**CHARTER TOWNSHIP OF GARFIELD
PLANNING COMMISSION MEETING**

Charter Township of Garfield Planning Department Report No. 2025-2			
Prepared:	January 2, 2025	Pages:	8
Meeting:	January 8, 2025 Planning Commission	Attachments:	<input checked="" type="checkbox"/>
Subject:	TowerNorth Wireless Communication Facility Special Use Permit – Public Hearing		
File No.	SUP-2024-02	Parcel No.	05-019-001-00 (part)
Applicant:	TowerNorth Development, LLC		
Agent:	Jaime Mathew w/Kimley-Horn and Associates, Inc.		
Owner:	Frank A Bare

SHEET TITLE:
ELECTRICAL
SITE PLAN
--

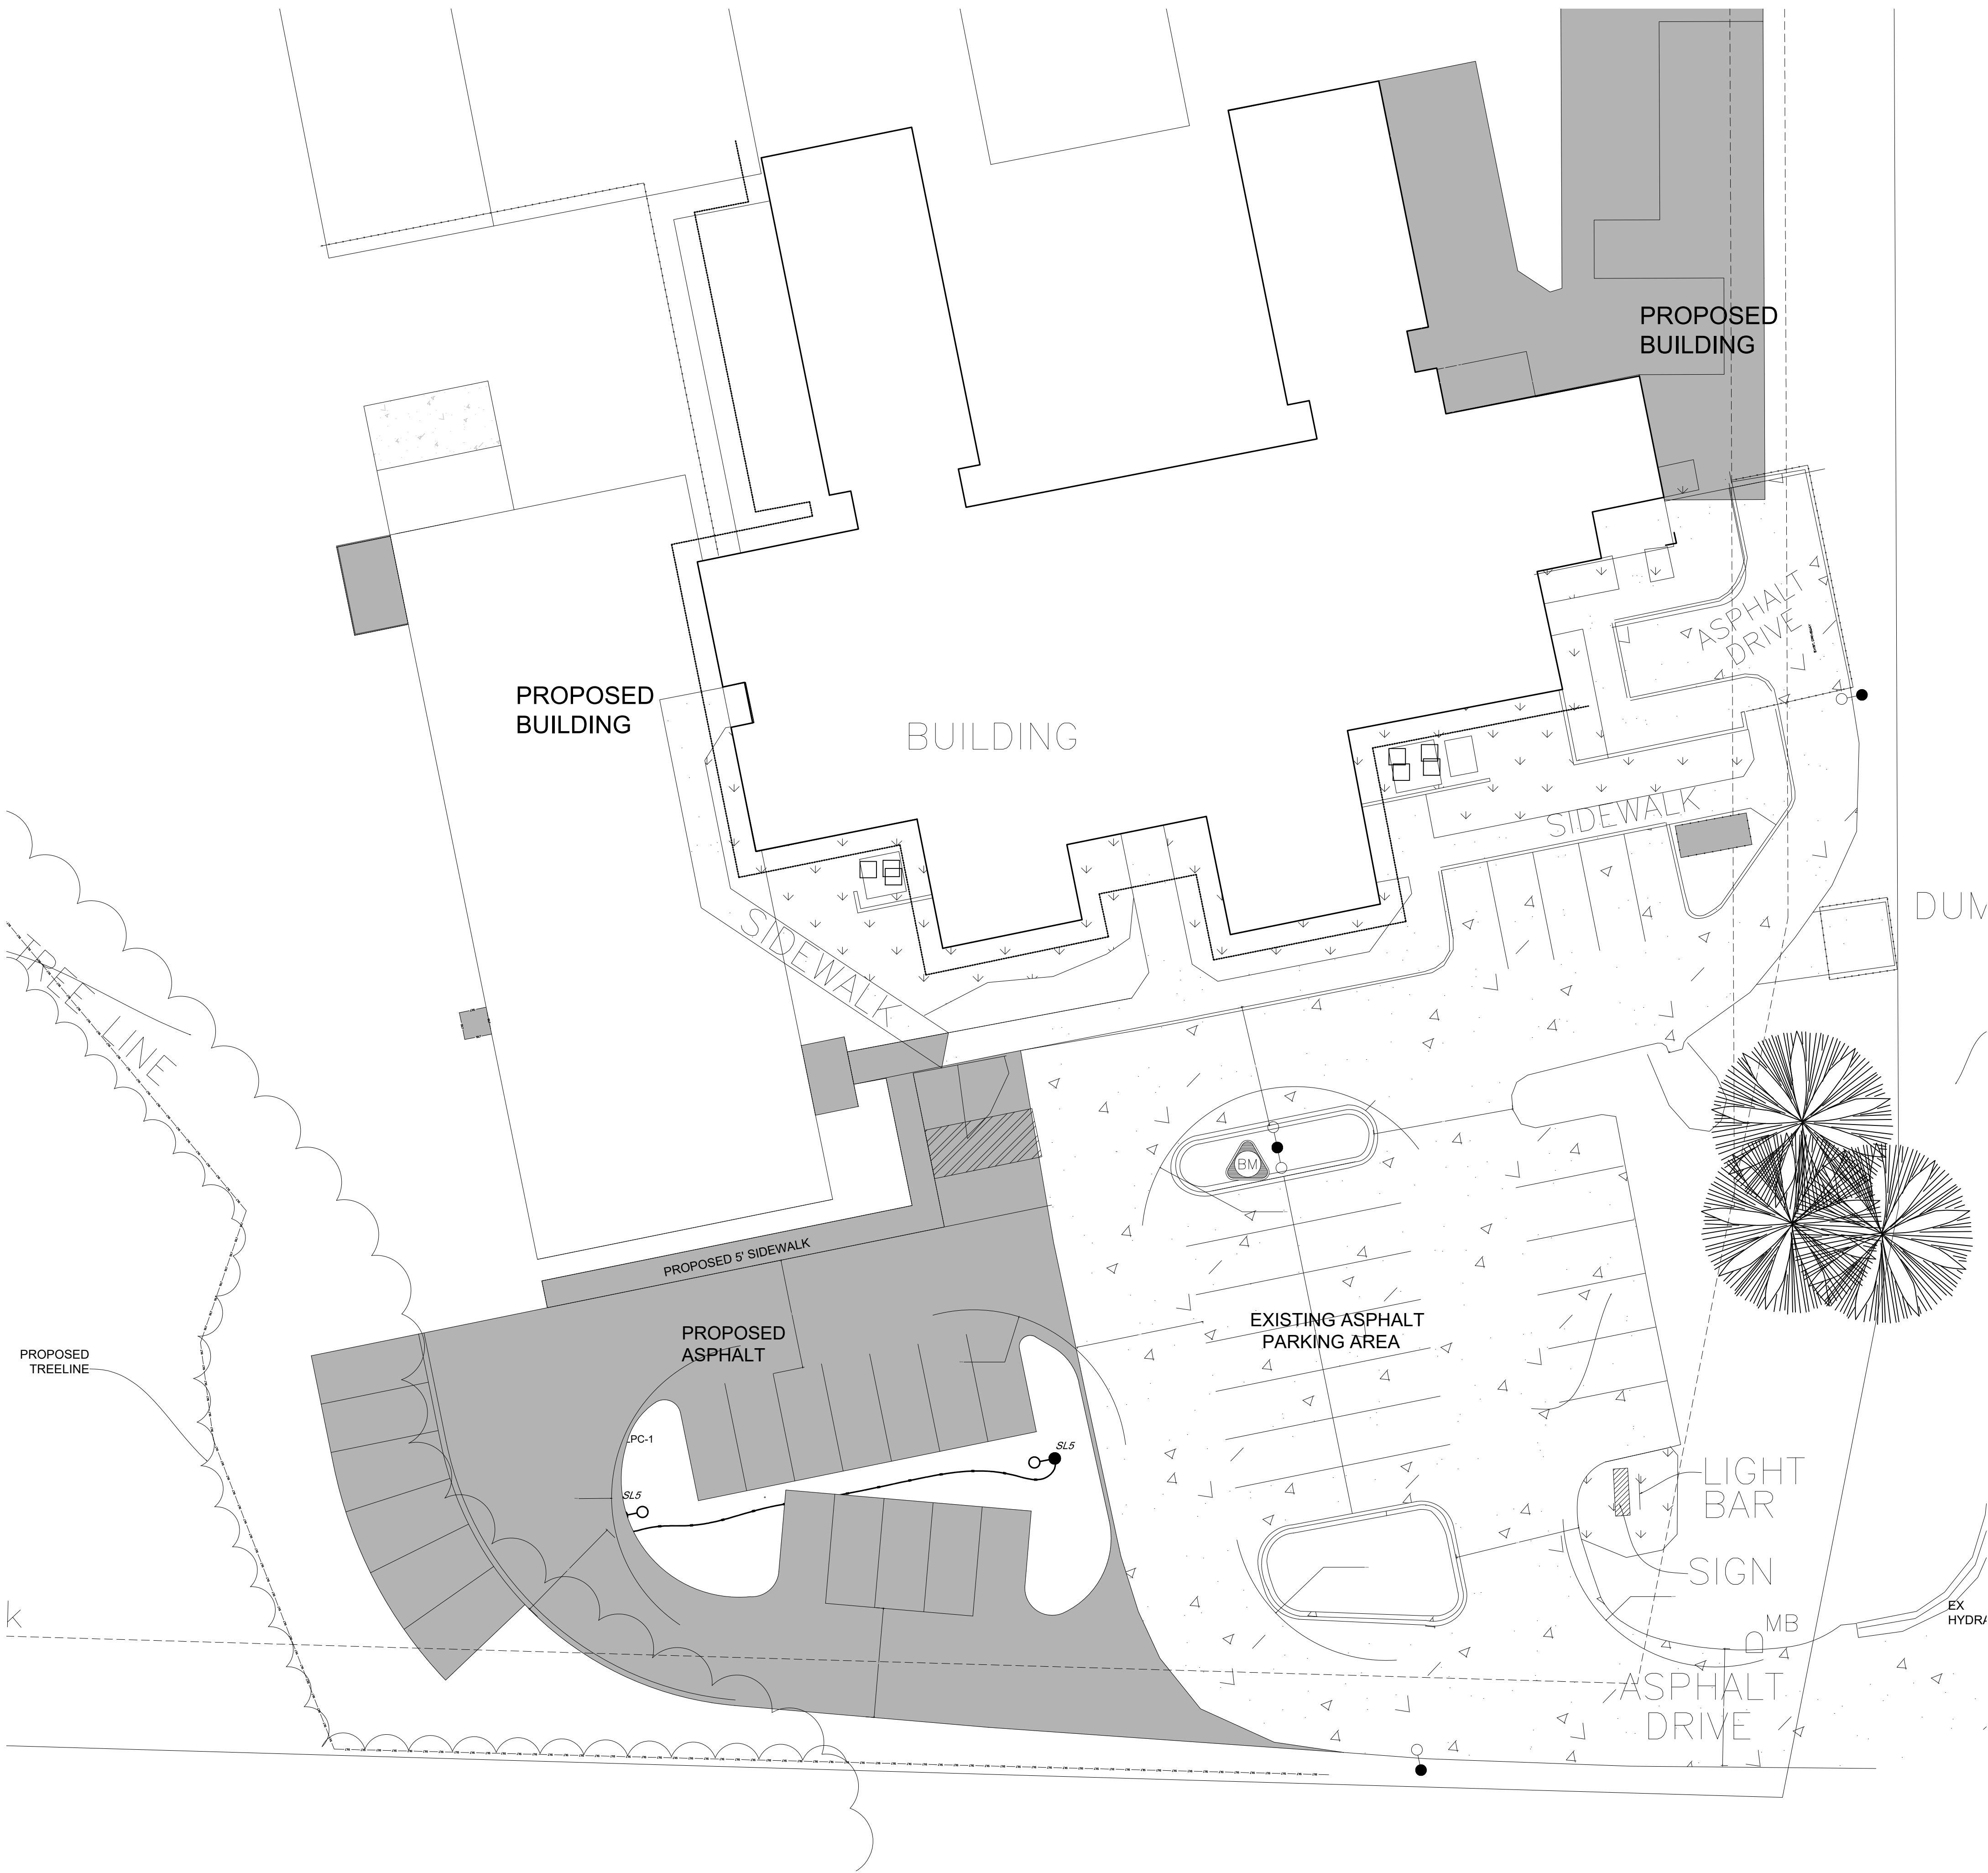
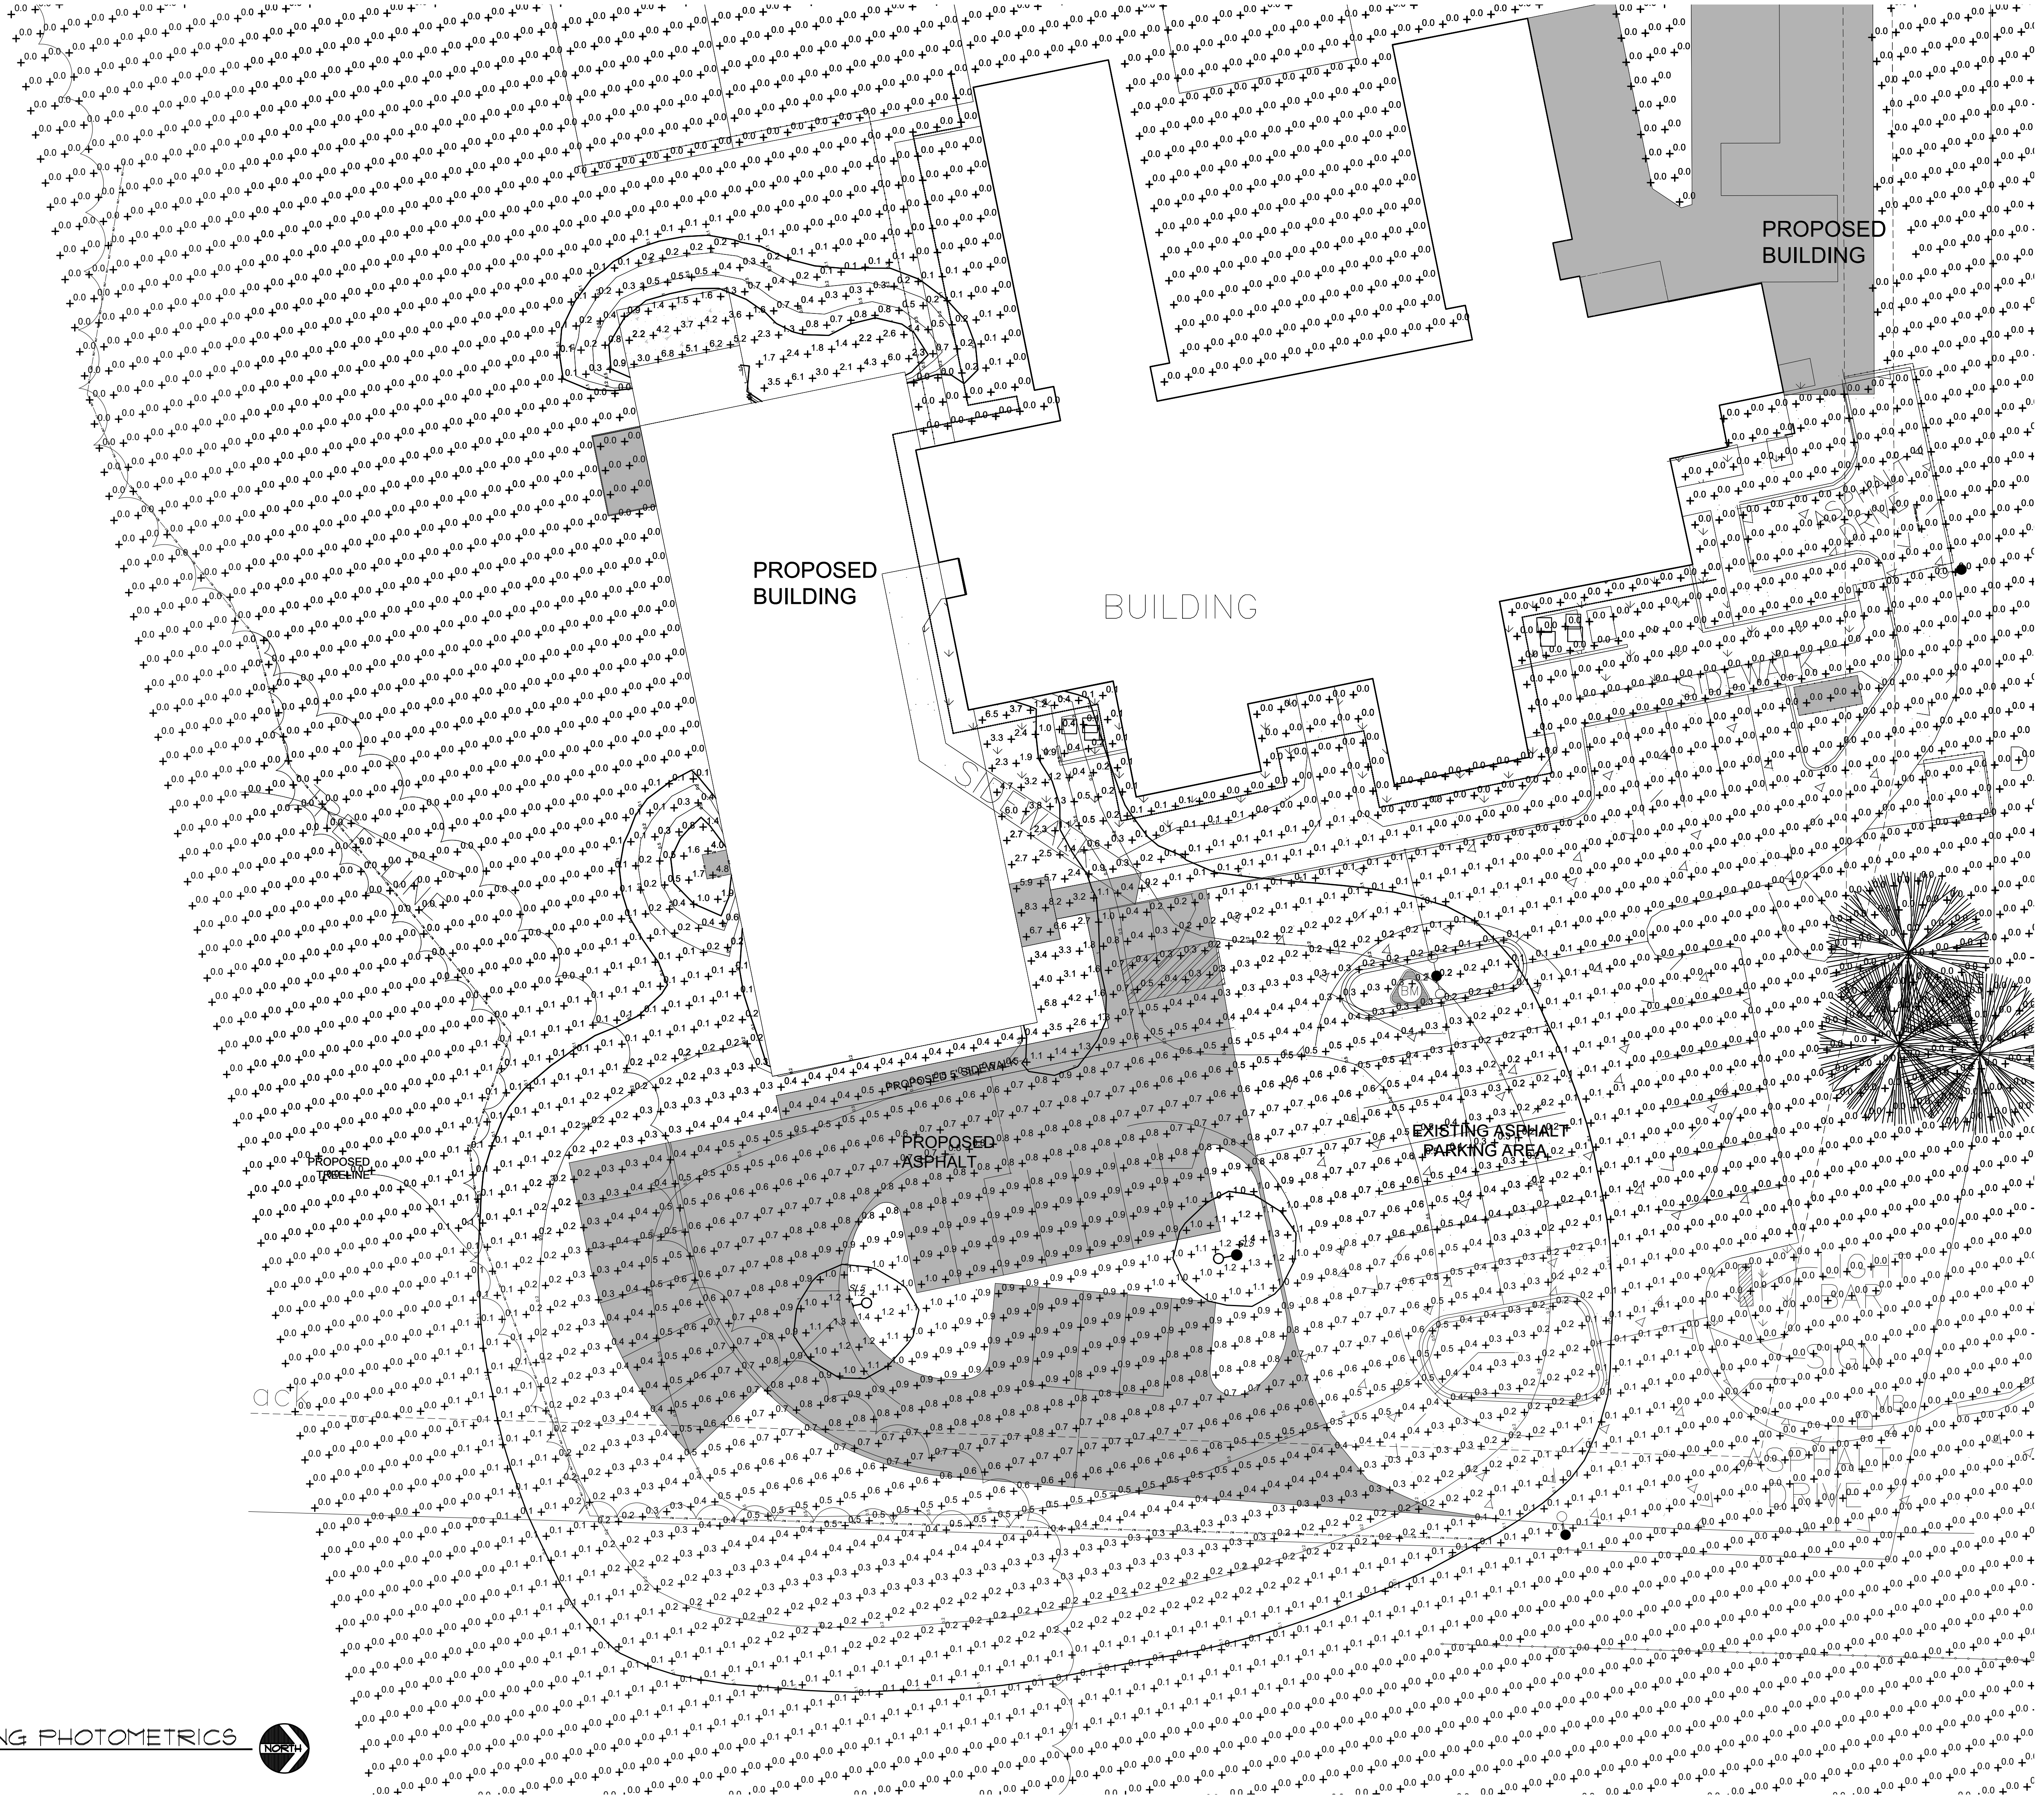
The site plan set includes an Electrical Site Plan (Sheet SE2.1) and Site Lighting Photometrics (Sheet SLC) to demonstrate site lighting. The applicant has also submitted a cut sheet of the proposed lighting fixtures. These site plan sheets, and the cut sheet of the proposed lighting fixtures, are both attached to this report. The lighting standards of Section 517 of the Zoning Ordinance are described by the following:
